Access Compliance Report

Public Rights-of-Way

Main Street: GILBERT_ST Cross Street: W BALL_RD Location: SW

ADA ID: SGRK210927173000 Signal Type: One Push Button-Non APS Overall Compliance: No Severity Scores: BTN 1: 25 BTN 2: N/A No BTN: N/A

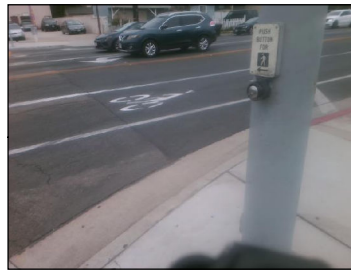
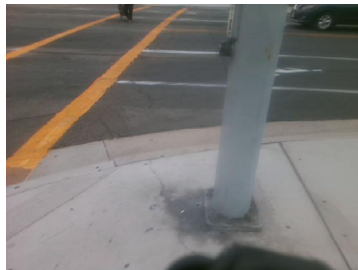
OC Std/PROW: R404.2, R404.3

Possible Solutions: Remove and Replace Clear Space.
